MAY 16, 2018
BOARD OF COUNTY COMMISSIONERS
ORANGE COUNTY FLORIDA
ADDENDUM NO. 2/IFB NO. Y18-759
ORANGE COUNTY PORTER TRANSFER STATION SITE IMPROVEMENTS

THE REVISED BID OPENING DATE IS MAY 22, 2018

SHEET TITLE: **CITIZEN DROP OFF / NEW HHW FOUNDATION, SLAB AND ROOF PLANS**
 PROJECT TITLE: **PORTER TRANSFER STATION SITE IMPROVEMENTS**

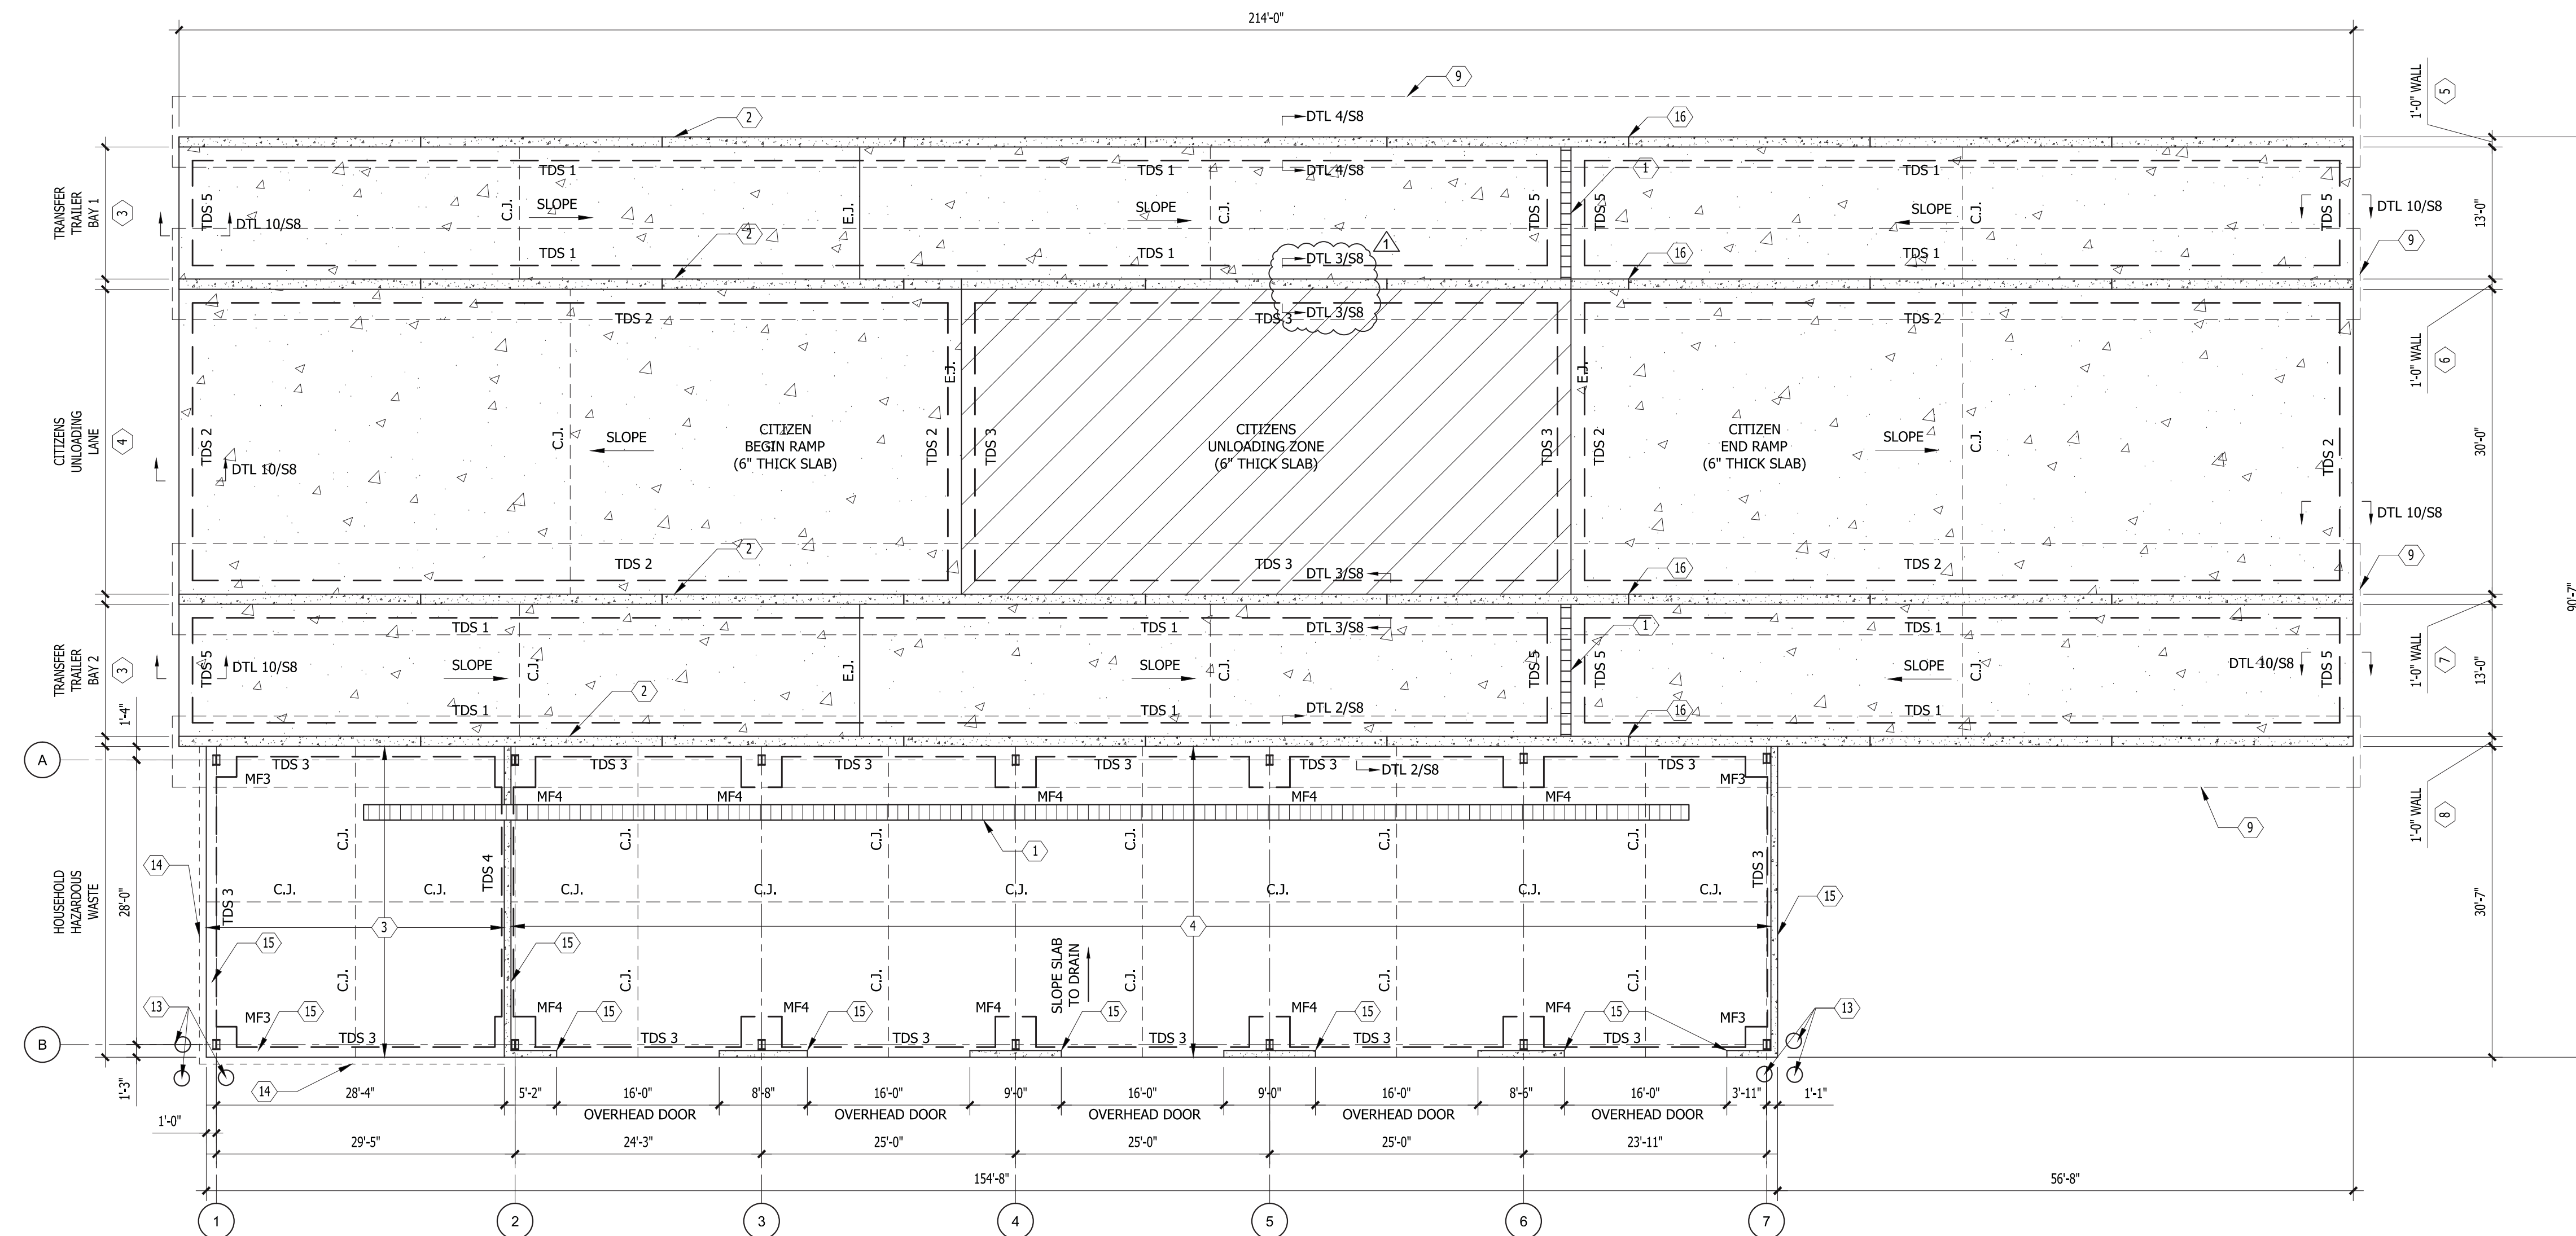
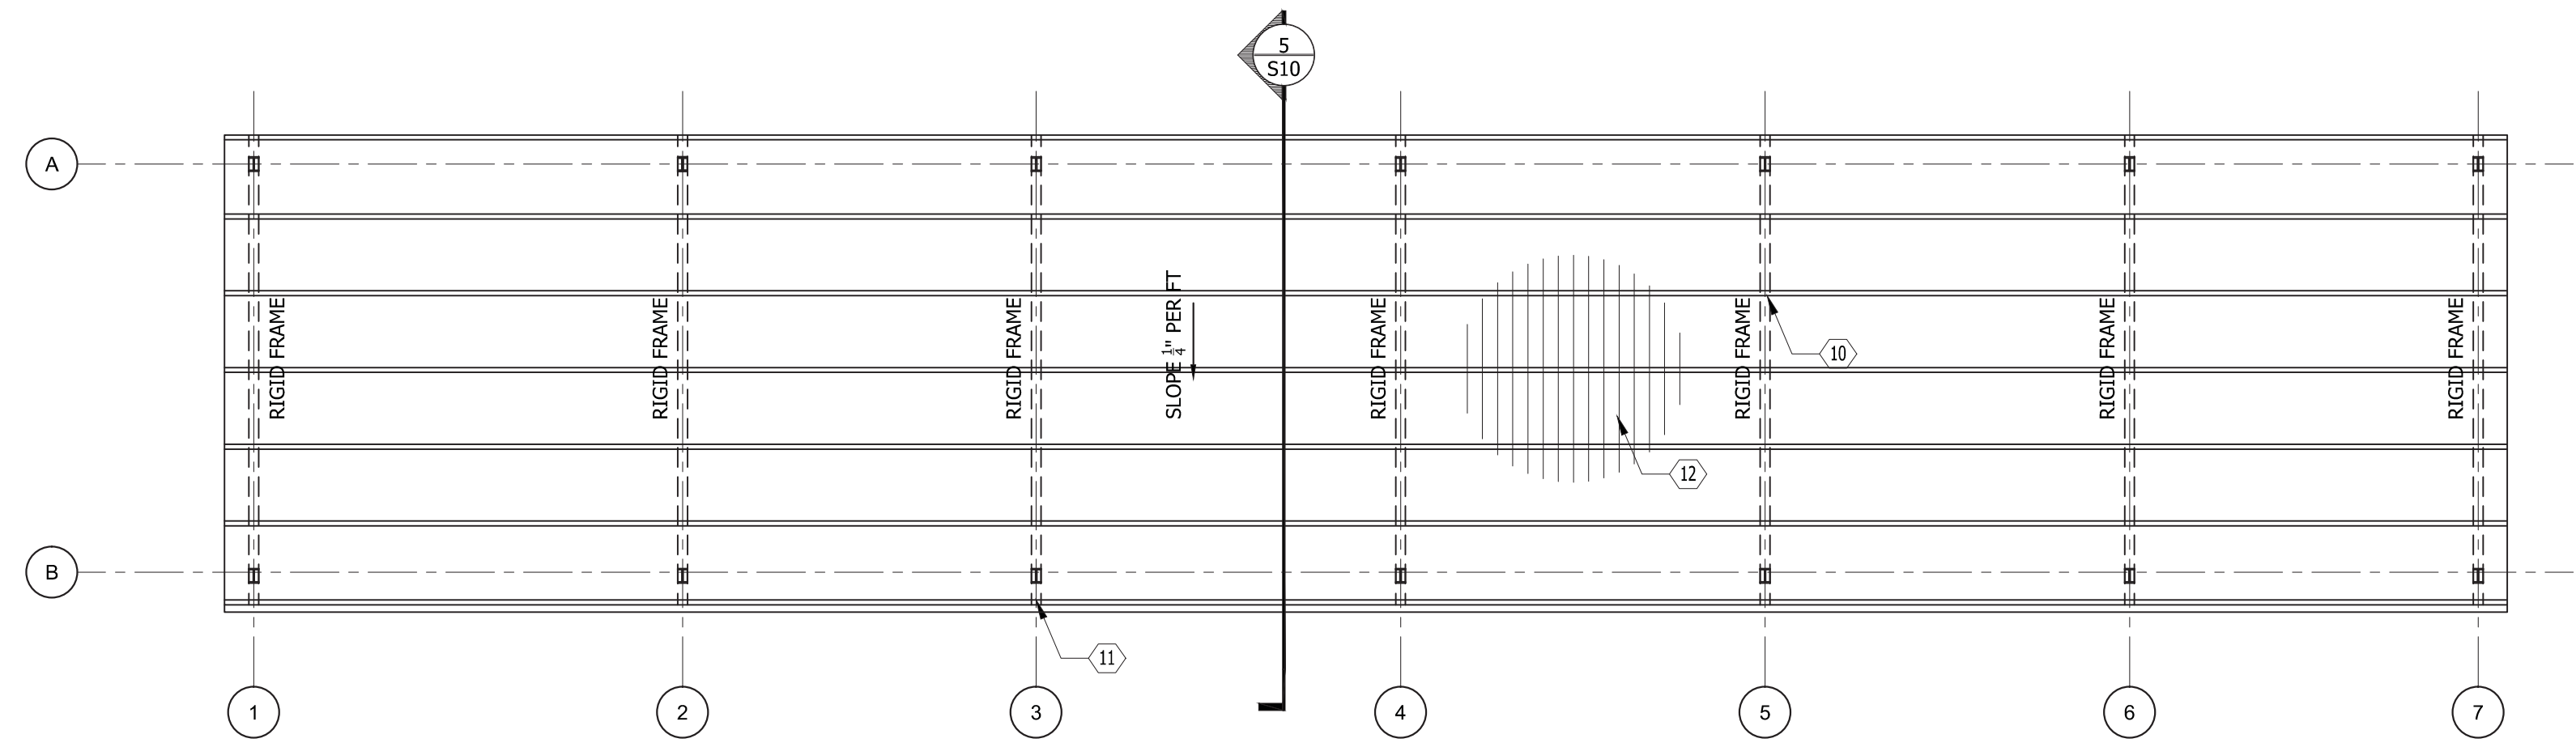
16. **Question:** Sheet S5 shows two different Foundation and Reinforcing Schedule tables with conflicting sizes and other information. Please specify which schedule is the correct one.

Response: Refer to the updated Drawing S5.

- A. DELETE and REPLACE Drawing S5 Revision 2 attached.
B. DELETE and REPLACE Drawing S10 Revision 1 attached.
